Request For Information

Project Name: Replace Roofs (Program Phase 1 - 4)
Title: Roof Replacement - Phase 1 Facility B

RFI#: 011

CCM Proj. # I-001123

A902

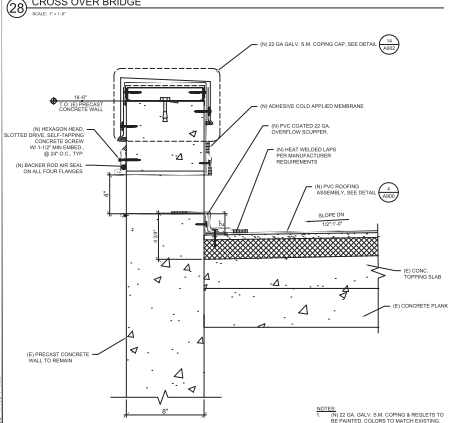
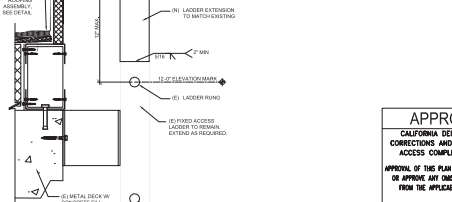
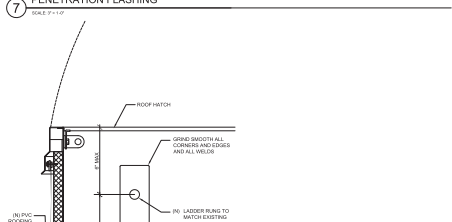
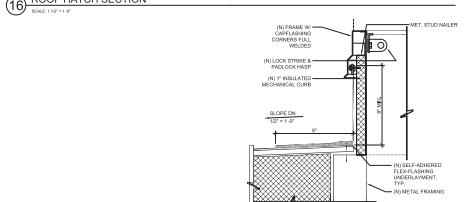
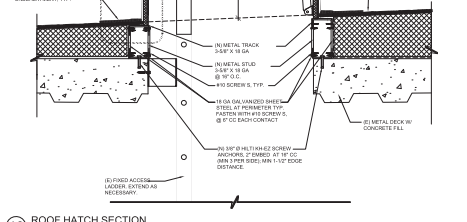
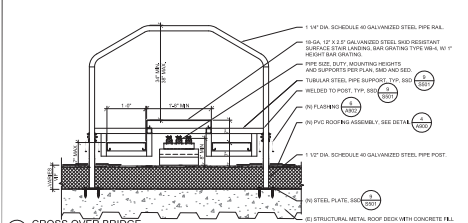
Project I-001123 Project Manual page 05 51 00-3, 1.5 (Design Requirements) section E, states to install metal stairs or ramps with skid resistant surfaces over roof piping over designated roof walkways. There will be several of these types of crossings over conduits on this project. Plan set 22-090 does not provide a detail for installation or design. CCM recommends the attached LAC plan set 21-040 pg. A902 detail 28 for fabrication and installation. Please Advise

Suggested detail is acceptable. A similar detail for this condition/project will be requested from the consultant and issued as a future construction bulletin.
